HOWELL TOWNSHIP PLANNING COMMISSION

REGULAR MEETING

3525 Byron Road
Howell, MI 48855
December 16, 2025
6:30 pm

- D. Resignation of Mike Newstead
12. Business Items
 - A. Old Business:
 - B. New Business:
 1. Dakota Haslock, PC2025-22, 3590 W. Grand River Ave., Parcel # 4706-28-100-024, Preliminary Site Plan Review

HASLOCK PROPERTIES, LLC
3590 W. GRAND RIVER AVENUE
HOWELL, MI. 48843
SITE PLAN

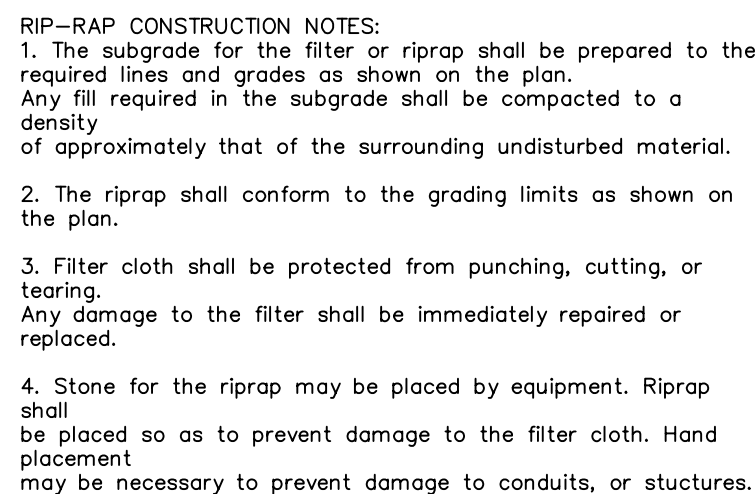
Section 18.02 requires Industrial Uses to provide one (1) parking space for every employee working during the largest working shift, or one (1) space for every 550 square feet of total floor space, whichever is greater. The applicant provided parking spaces based on the square footage of the building shown on Sheet 3.

- 1) Update note on Sheet 3 to say 10 parking spaces, instead of 5.*
- 2) Driveways and parking areas shall be asphalt or concrete.*
- 3) Add parking islands to the end of parking bays.*

The applicant proposes two (2) fences, a six (6) foot tall opaque fence along Grand River Ave. and a four (4) foot tall chain linked fence around the retention pond shown on Sheets 3 and 4. Fences are not allowed in the front yard setback. There is also an existing chain linked fence at an unspecified height on Sheets 3 and 4 as well. Chain linked fences are not allowed to be used as obscuring fences. Sheet 5 shows a different fence proposal showing a slit fence with an unknown height all around the site. The applicant shall specify which fence is being proposed.

5. Provide proposed location for outdoor storage areas and a circulation plan.
6. Move utility pole.
7. Update note on Sheet 3 to say 10 parking spaces, instead of 5.

The cross-hatched areas on Sheet 3 shows where the outside storage is proposed. The applicant shall provide information on what will be stored on site.

Section 18.02 requires Industrial Uses to provide one (1) parking space for every employee working during the largest working shift, or one (1) space for every 550 square feet of total floor space, whichever is greater. The applicant provided parking spaces based on the square footage of the building shown on Sheet 3.

HASLOCK PROPERTIES, LLC
3590 W. GRAND RIVER AVENUE
HOWELL, MI. 48843
EXISTING CONDITIONS - DEMO PLAN

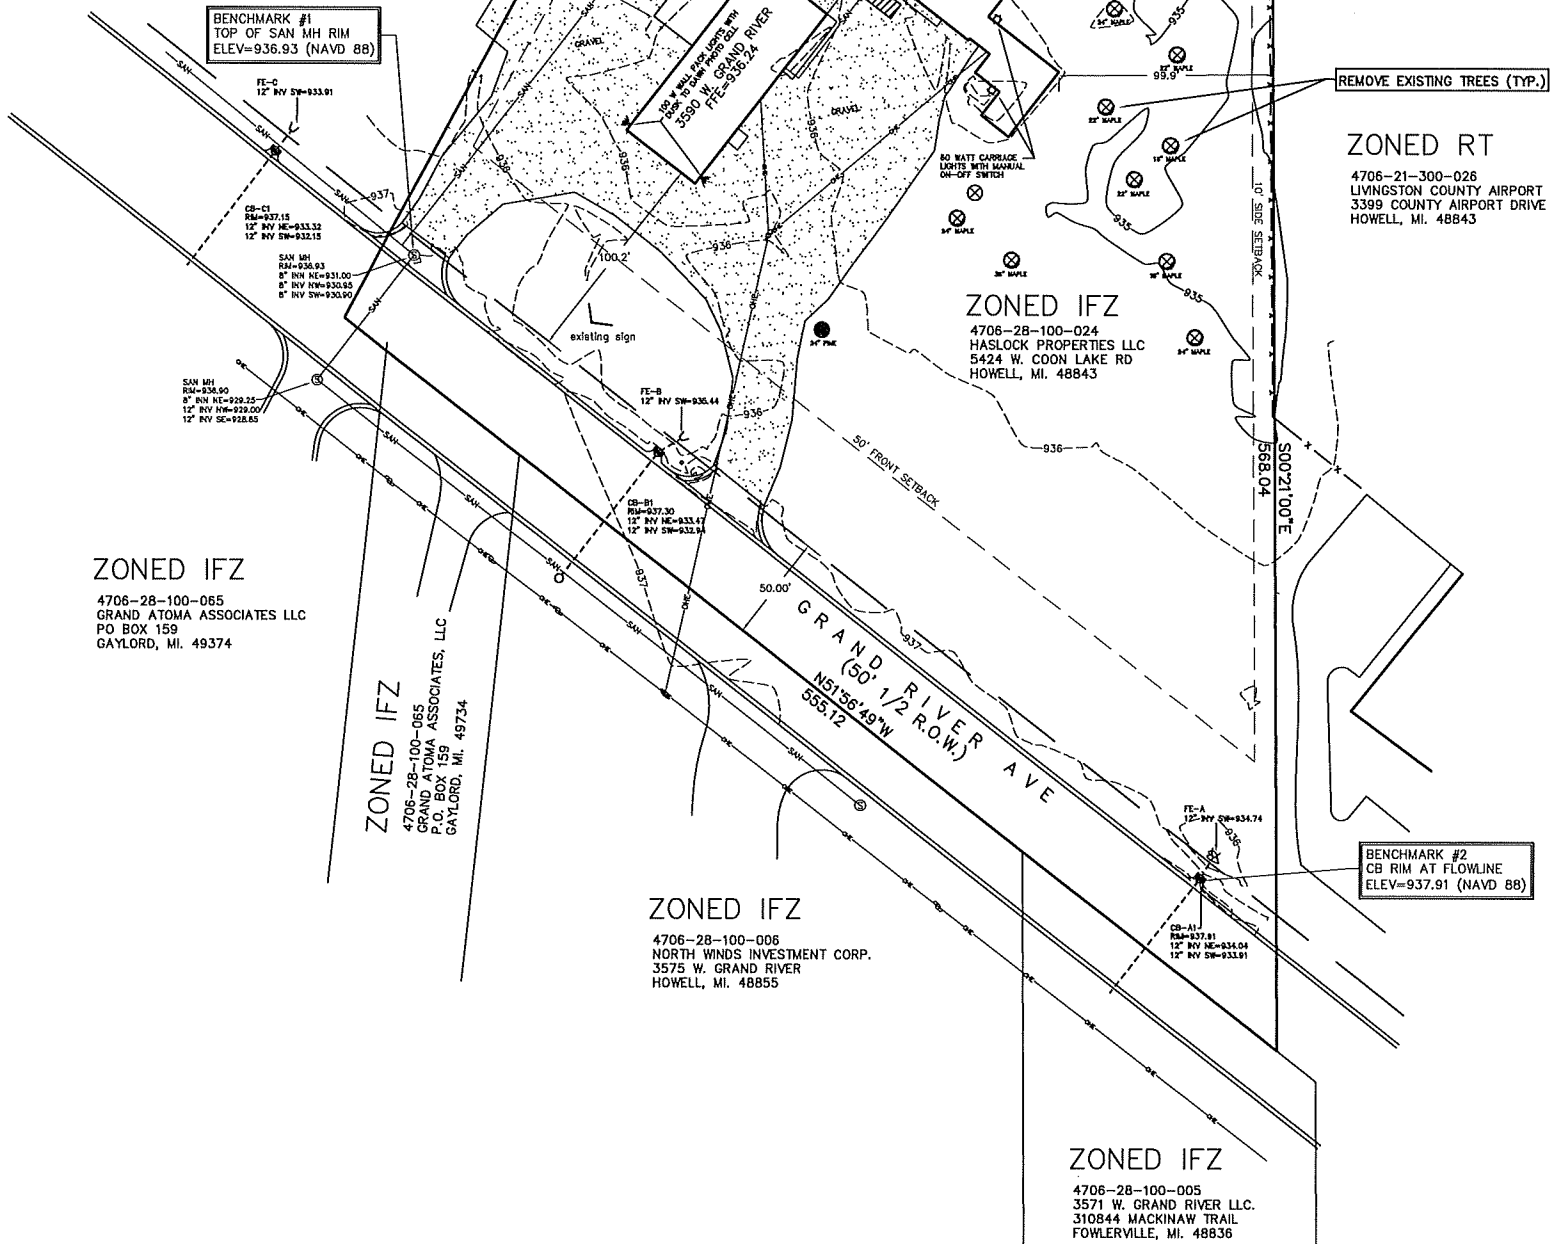
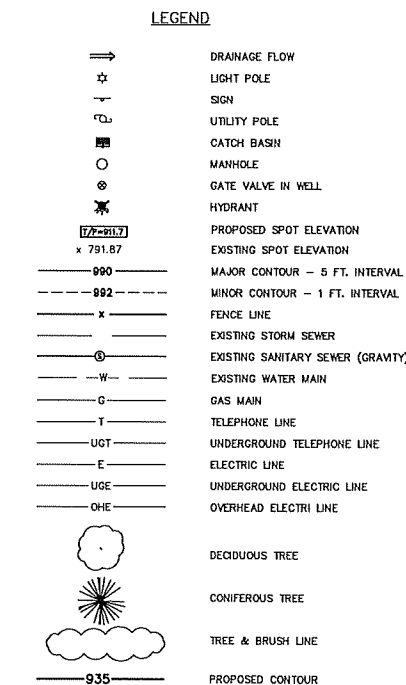
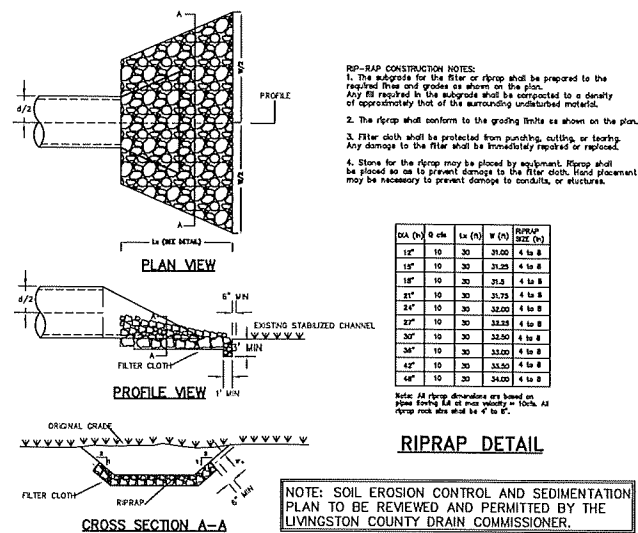
The site has no woodlands and no water features. There are fourteen (14) maple trees that have calipers between twelve (12) and thirty-six (36) inches that the applicant is planning to remove as shown on Sheet 2. These trees will be removed for a proposed retention pond as shown on Sheets 3,4, and 5. **Figure 4** shows what the property looked like in July 2025.

The applicant plans on removing fourteen (14) maple trees that range from twelve (12) inches to thirty-six (36) inches in caliper sizes as shown on Sheet 2. The trees are being removed for a proposed water retention pond shown on Sheets 3, 4, and 5. The applicant did not provide how many feet the perimeter of the proposed pond is. Required detention pond landscaping calculations are based on the perimeter measurement.

The Existing Conditions Sheet (Sheet 2) includes all of the required information. All property lines are shown, and the zoning of the adjacent properties is included. The adjacent road, Grand River Avenue, is clearly identified. Topographical contours at one-foot intervals are provided. The locations of all existing buildings and all trees greater than six inches in diameter are identified, and the existing utilities are shown.

The site has no woodlands or water features. There are fourteen (14) maple trees that have calipers between twelve (12) and thirty-six (36) inches that the applicant is planning to remove as shown on Sheet 2. These trees will be removed for a proposed retention pond as shown on Sheets 3,4, and 5.

SITE PLAN

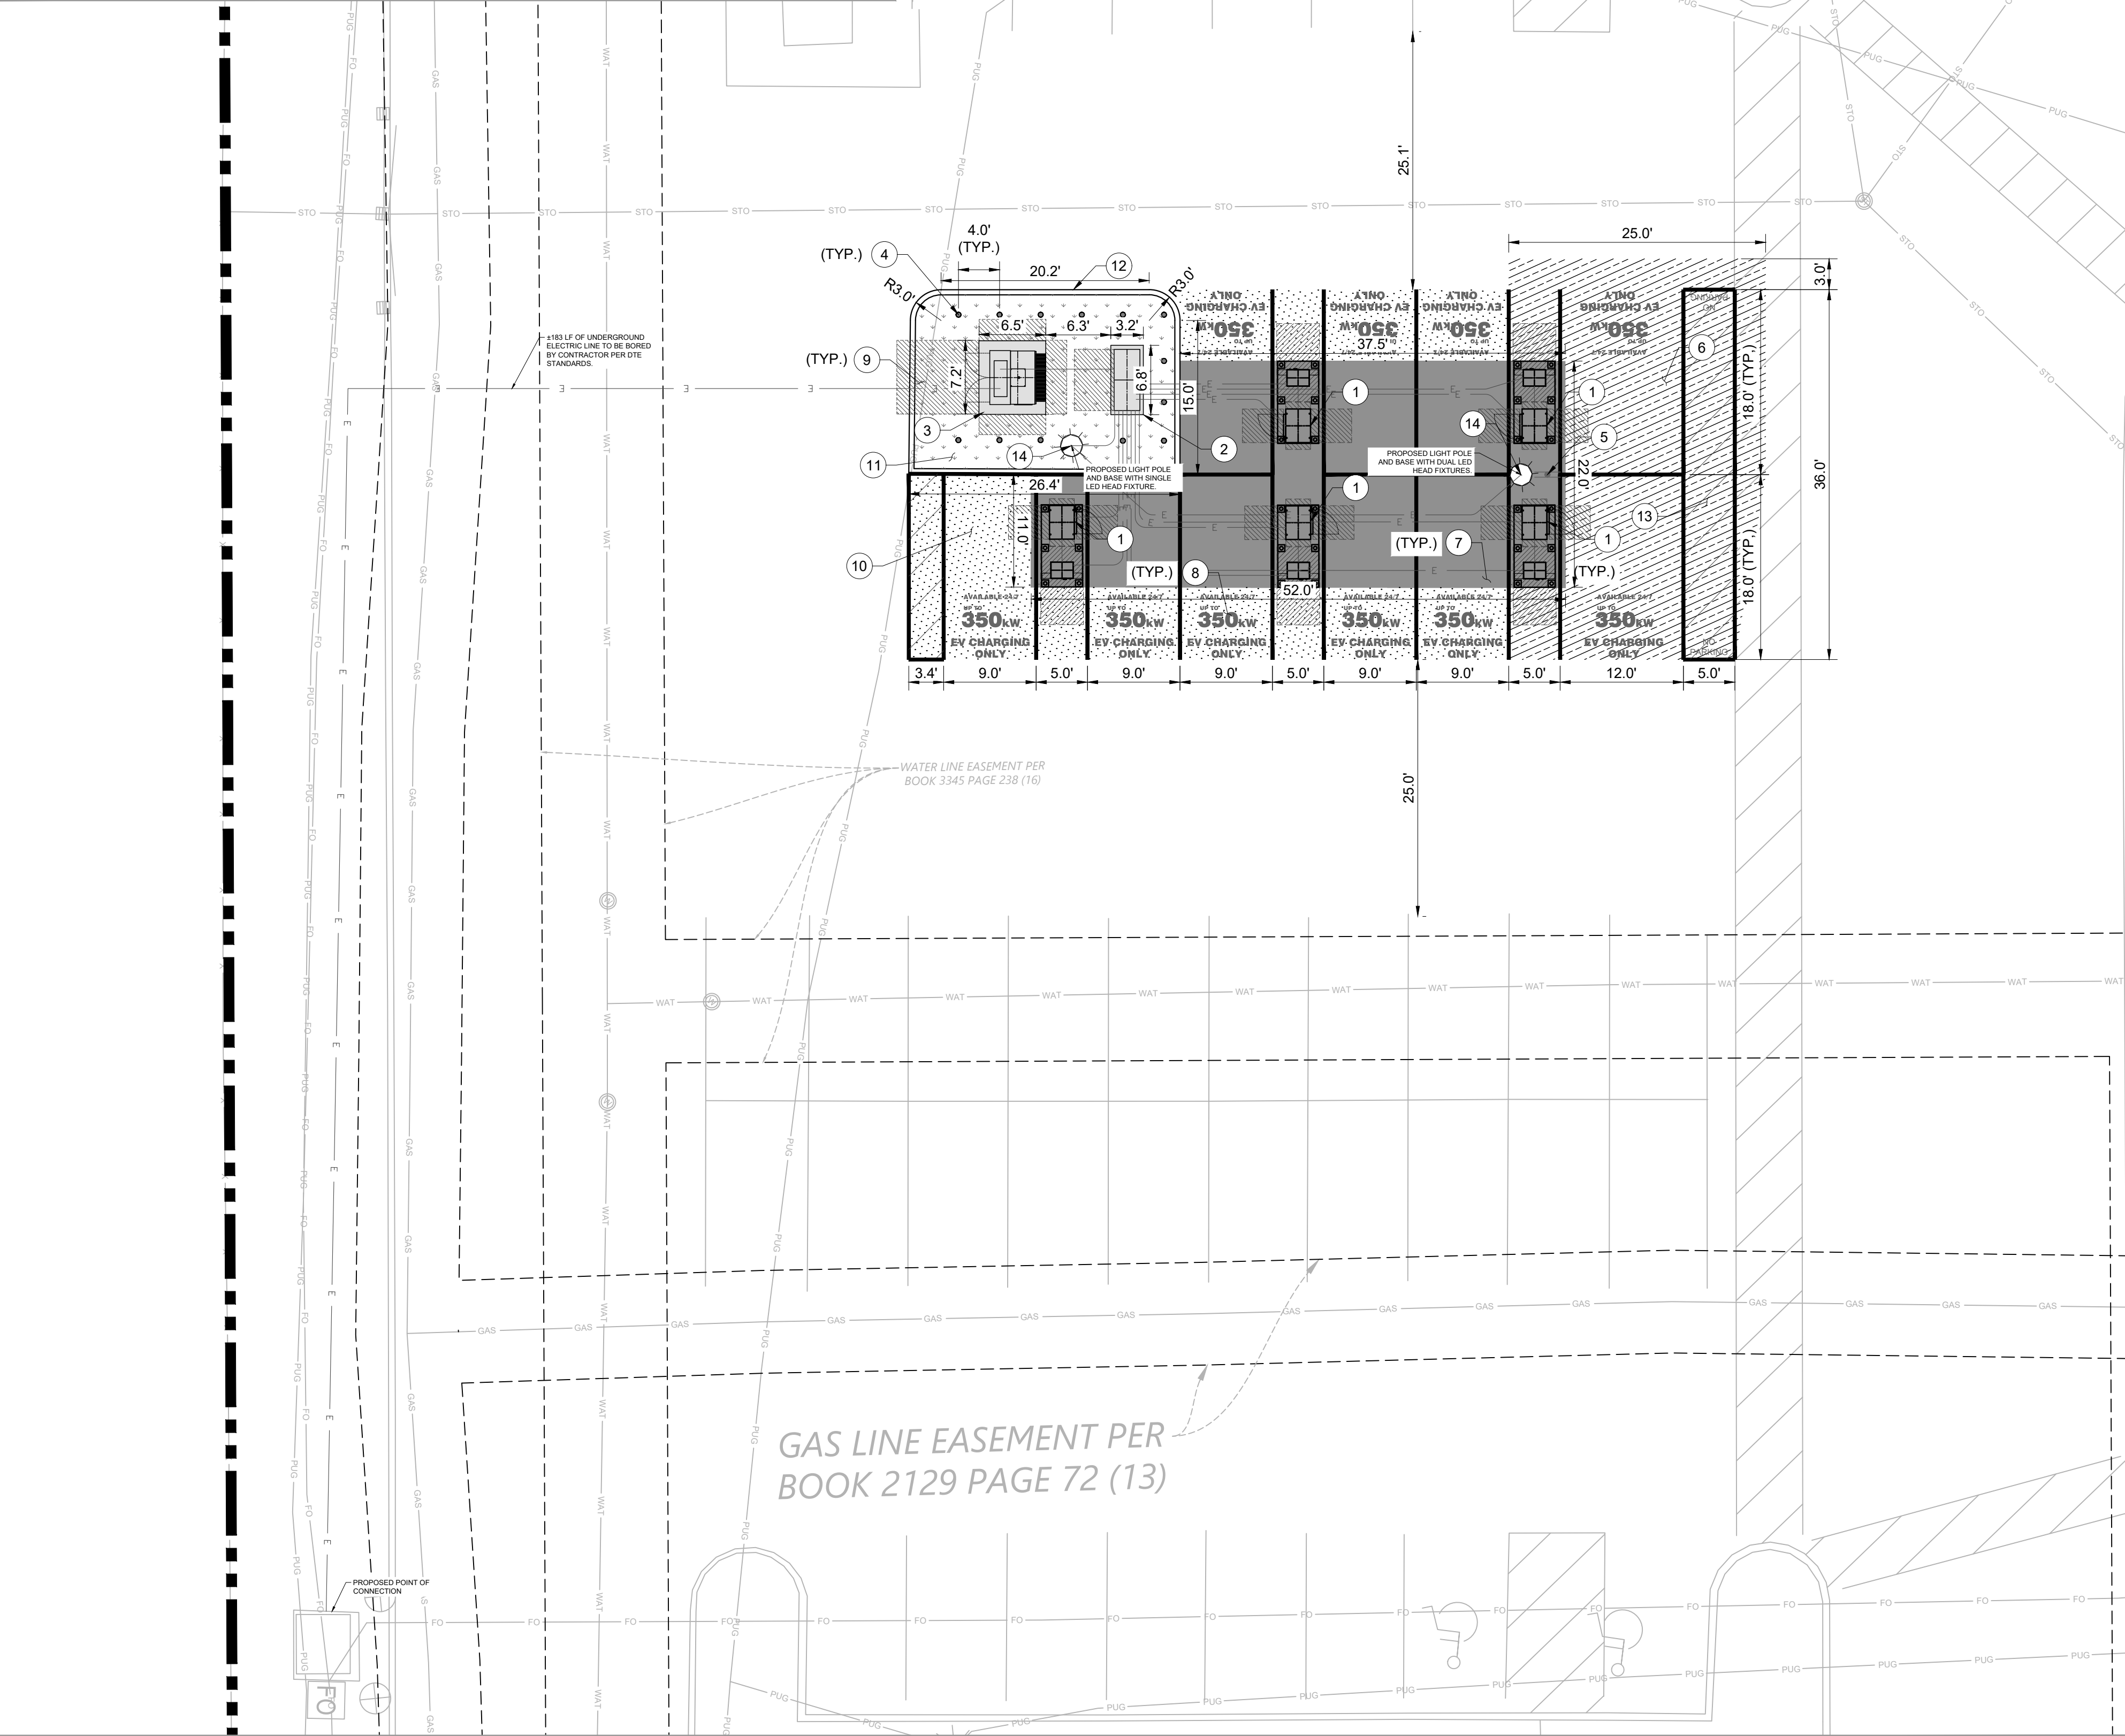
The applicant is requesting to redesign 16 standard parking stalls into 10 standard electric vehicle charging stalls of which 2 will be ADA accessible. Additional information on the layout of the parking stalls can be found on Sheet C3.0. This will create a loss of 6 parking spaces from the site. The charging stations will allow for 350 kilowatts of charging. The location of for the proposed parking space conversion is shown in red on the aerial image below:
